**SUBJECT:** 200 John Street East and 588 Charlotte Street  
Files OPA-02-2020, ZBA-11-2020 & 26T-18-20-01  
Peer Review – Drainage and Stormwater Management

**RE: Drainage and Stormwater Management  
Peer Review of Randwood Estates Development Proposal,  
Niagara-on-the-Lake, Ontario**

The residential neighbourhoods to the north are shown here.

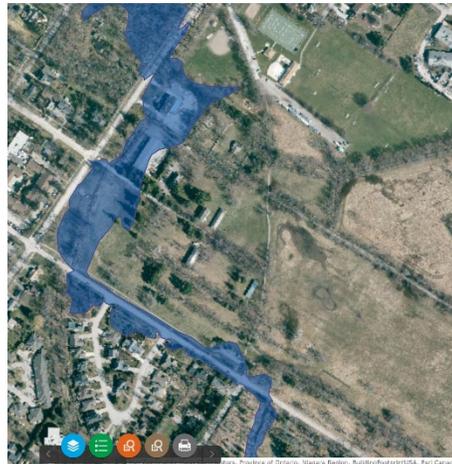
We note that Wood has indicated that there is insufficient analysis of the on-site and receiving watercourses with regard to flood flows. Furthermore, it appears that a more thorough and comprehensive erosion analysis is required. Given that parts of the site as well as the downstream area are flood prone and regulated by the Niagara Peninsula Conservation Authority (“**NPCA**”), it is critical that this work be properly completed. WSP also flagged this issue in its memorandum of May 19, 2021 which was forwarded to you on June 16, 2021.

These extracts show that the flood plain includes the Lincoln and Welland Regiments Museum and residential neighbourhoods between King Street and Simcoe Street north of Williams Street. The flood plain continues west of Simcoe Street as well.
